Notice of Allowability

09/928,402

Juan A. Torres

FREIDHOF ET AL.

Fig. 6

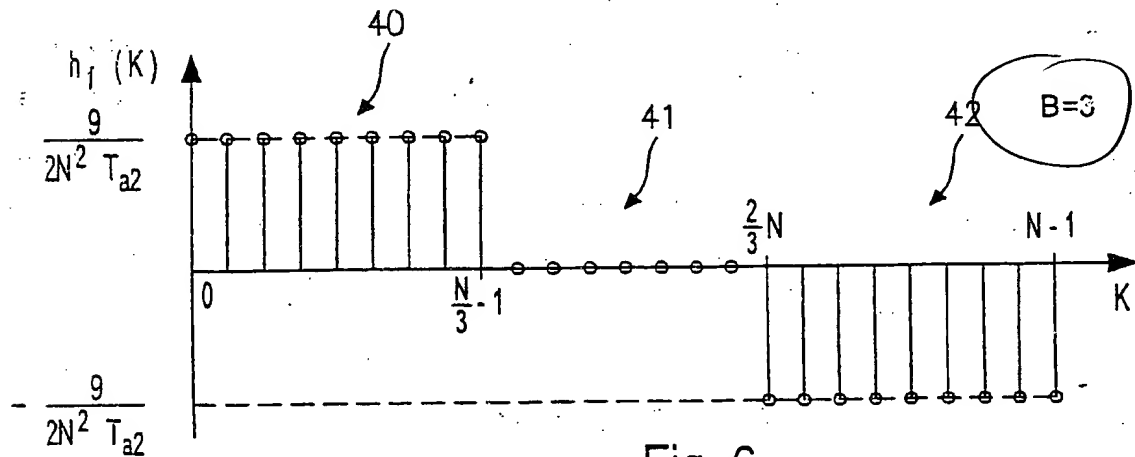
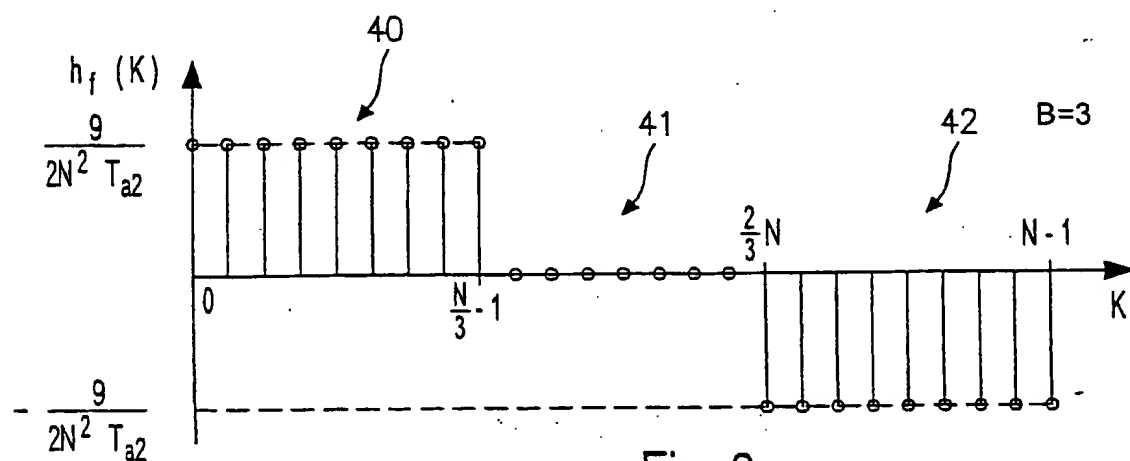
The drawings are objected to under 37 CFR 1.83(a). The drawings must show every feature of the invention specified in the claims. Therefore, the features of claims 1, 2, 8, 9, 10, 11 and 12 for a general value of B and for $B=3n$ must be shown or the feature(s) canceled from the claim(s). No new matter should be entered.

To Figs. 6 and 7, the reference label "B=3" was added, and to Figs. 9 and 10, the reference label "B=6" was added.
